## SEAS D7 RESPONSE to D6 submissions

### TRAFFIC & TRANSPORT

# Technical Note

**Subject:** Deadline 6 submission review

Figure 2: A12 Seasonality – SCC ATCs

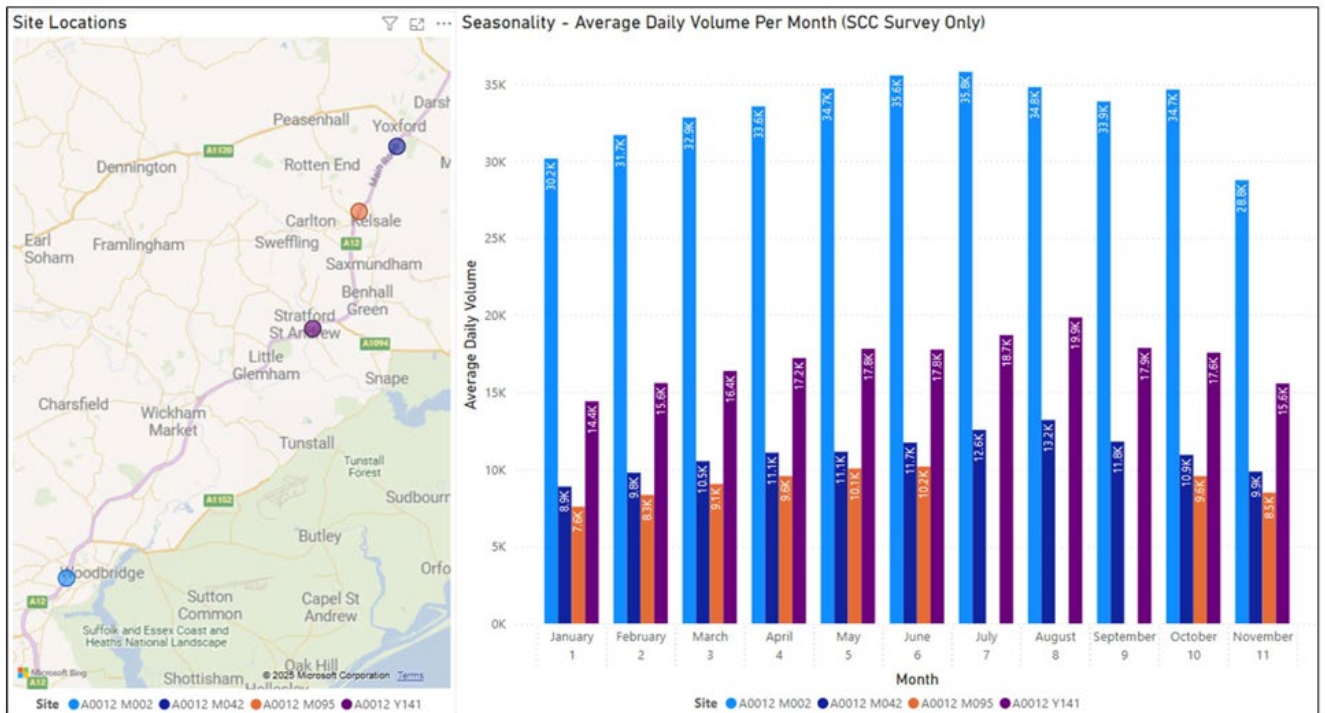
2.3.6 Flows at the nearest ATC location to this junction range from broadly 14,000 to 20,000. With an average flows of 17,000 vehicles per day at this location, again using the 10% rule, one would expect flows at the junction to be c1,700 vehicles per hour. In the busy summer months this would increase to c2,000 vehicles per hour.

2.3.7 This discrepancy is such we would question if the base flows used are correct. Notwithstanding that, even if they are, it is evident that the use of non-neutral January/February data is considerably underestimating traffic flows at this particular location.
